**THE RAIL YARD**  
18-30 LANGDON AVENUE  
CONCORD, NH

**UTILITY LAYOUT PLAN**

SHEET  
**C-5.0**

THE UTILITY PLAN HAS BEEN REVISED FOR ADMINISTRATIVE APPROVAL FOR THE RAIL YARD PHASE 2 (PREVIOUS KNOWN AS PHASE 3 & 4) RESIDENTIAL MULTIFAMILY PROJECT.

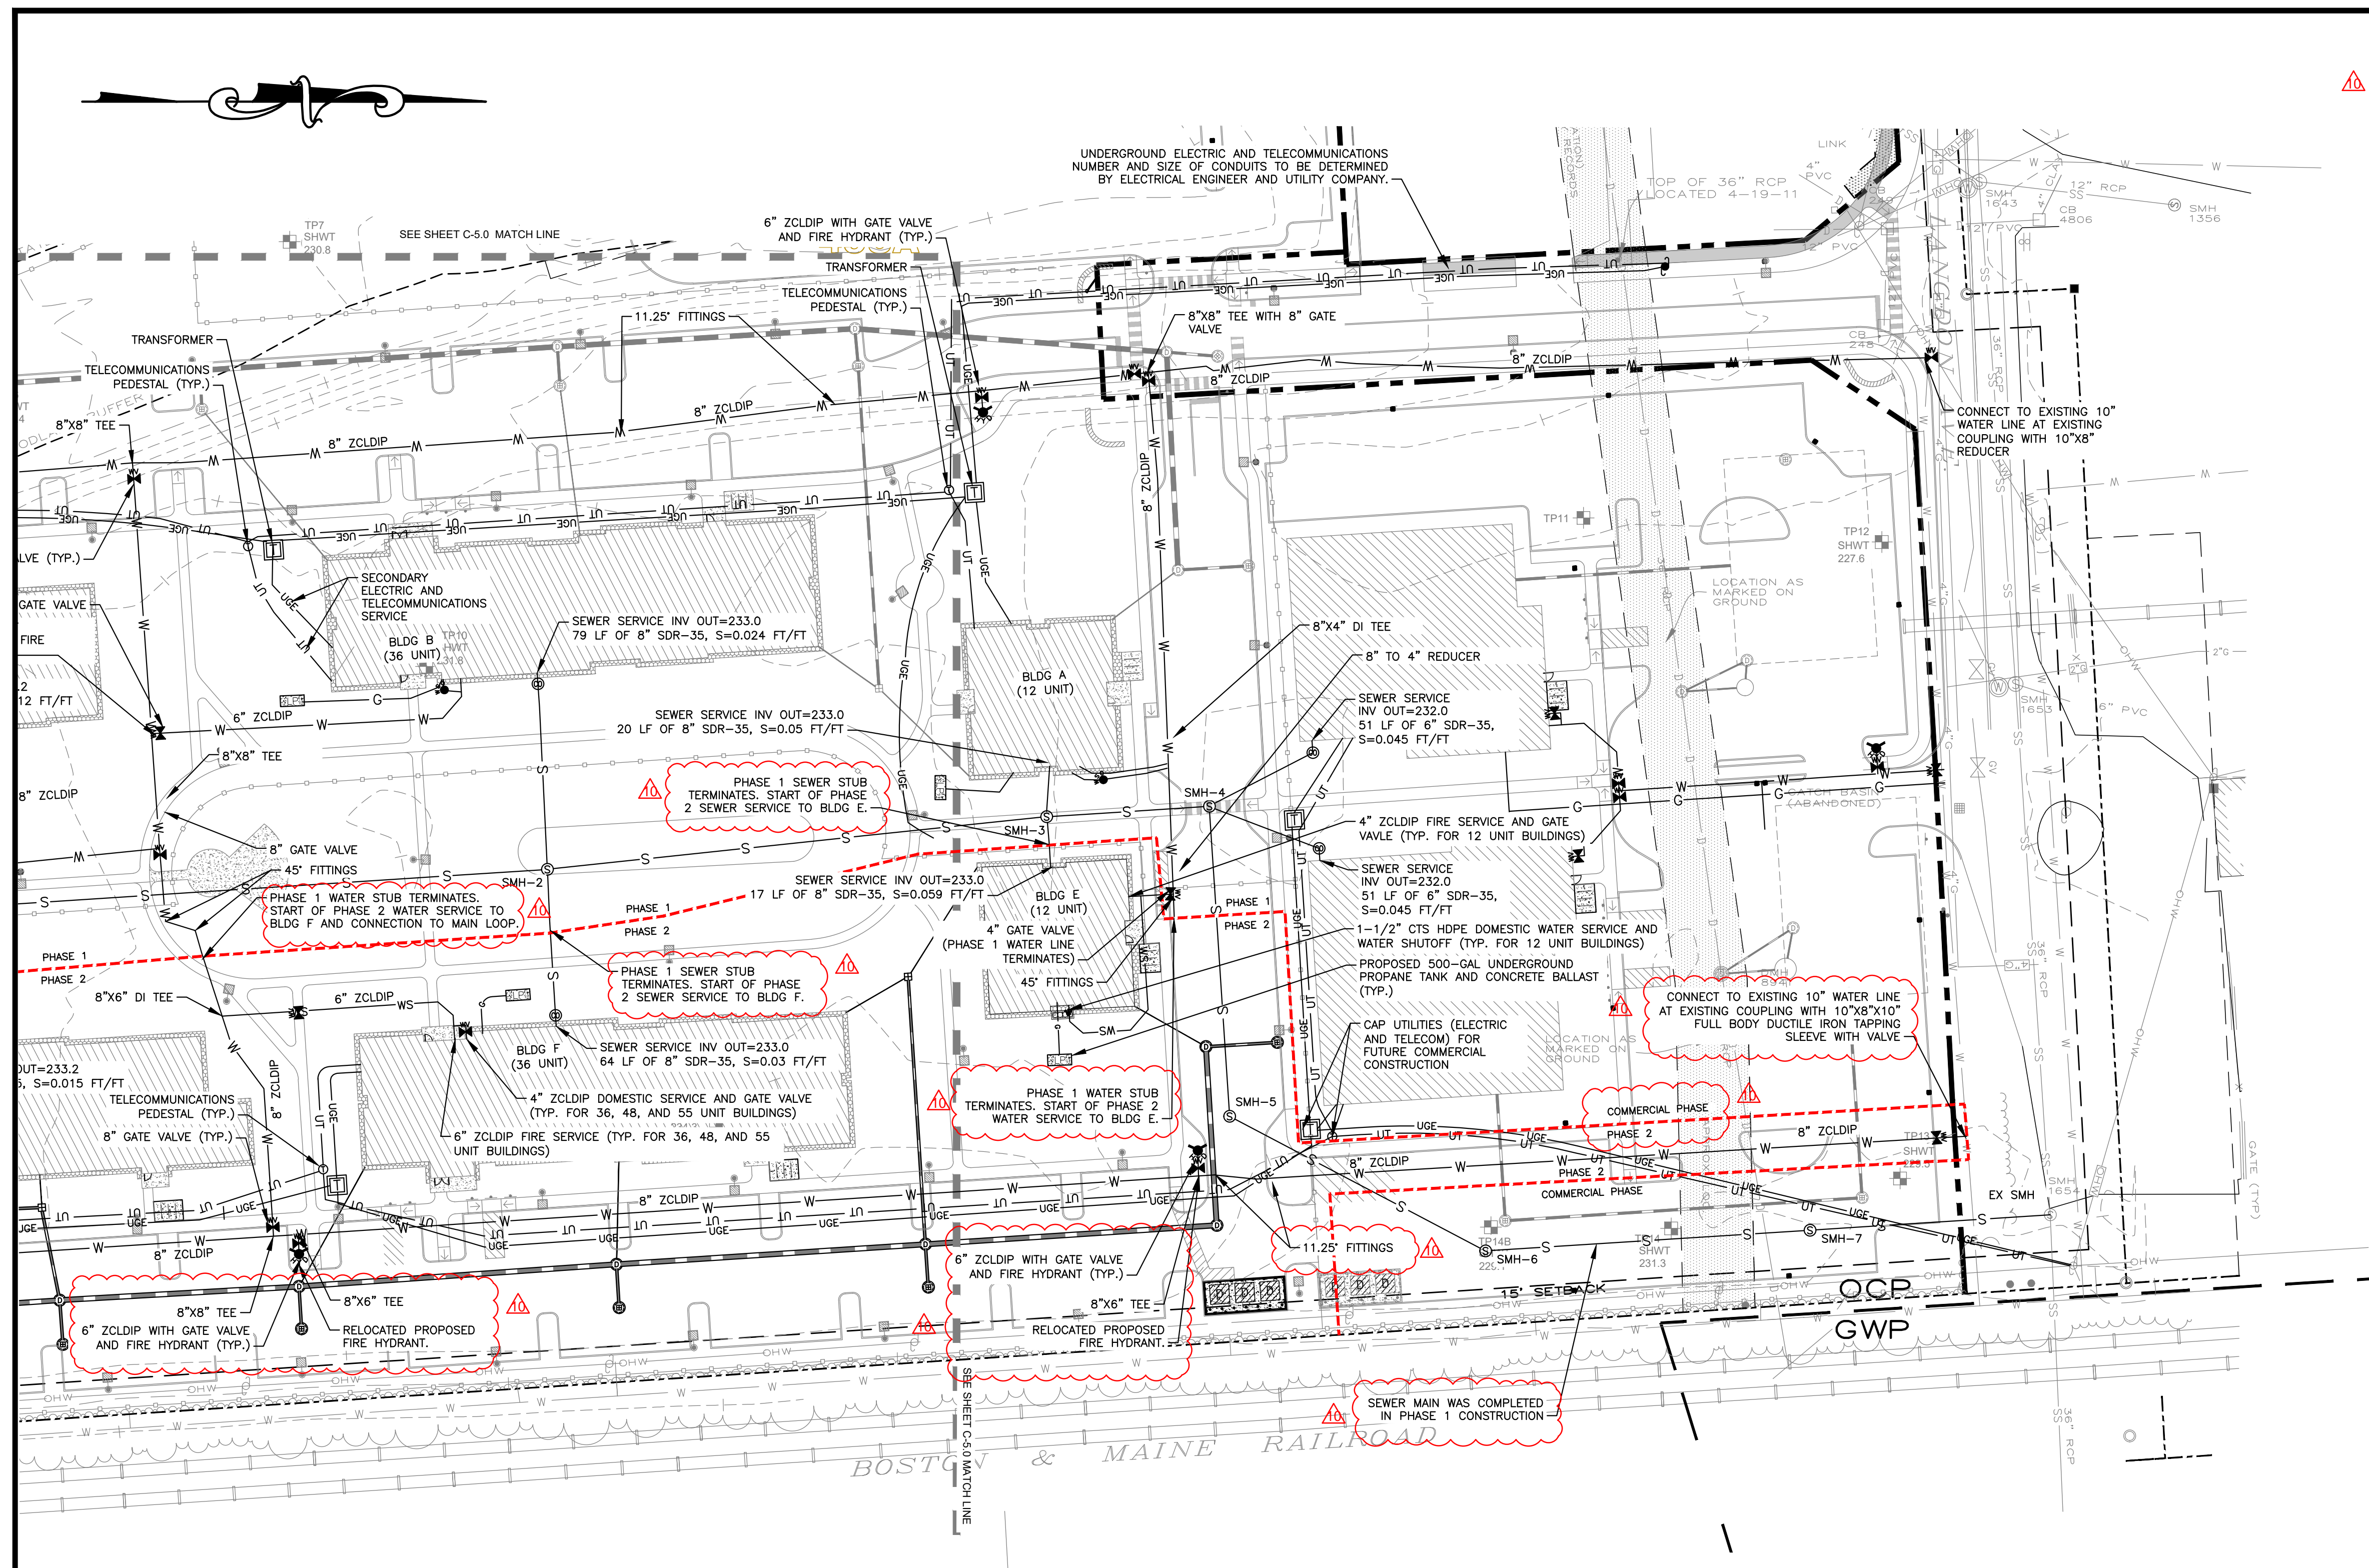
THE FOLLOWING CHANGES WERE MADE FROM THE APPROVED PLANS:  
1. WATER MAIN CONFIGURATION WAS REVISED AND APPROVED BY JOSE LOVELL ON MARCH 8, 2023. APPROVED SKETCH AND EMAIL CHAIN HAS BEEN PROVIDED.  
2. FIRE HYDRANT LOCATIONS HAVE BEEN REVISED TO HAVE A MAX 500-FT SEPARATION, ONE ADDITIONAL FIRE HYDRANT WAS ADDED TO THE SCOPE.  
3. PLAN SHOWS WHERE PHASE 1 UTILITIES TERMINATED AND WHERE PHASE 2 UTILITY WORK IS TO BEGIN.  
4. PREVIOUS PLAN SHOWED NATURAL GAS LINE WHICH WAS REMOVED FROM THE PROJECT AND PROPOANE TANKS WERE INSTALLED AS SHOWN/PROPOSED.

PL-ADM-2026-0143 administratively approved for the noted relocated water line at Langdon Ave. on June 3, 2026
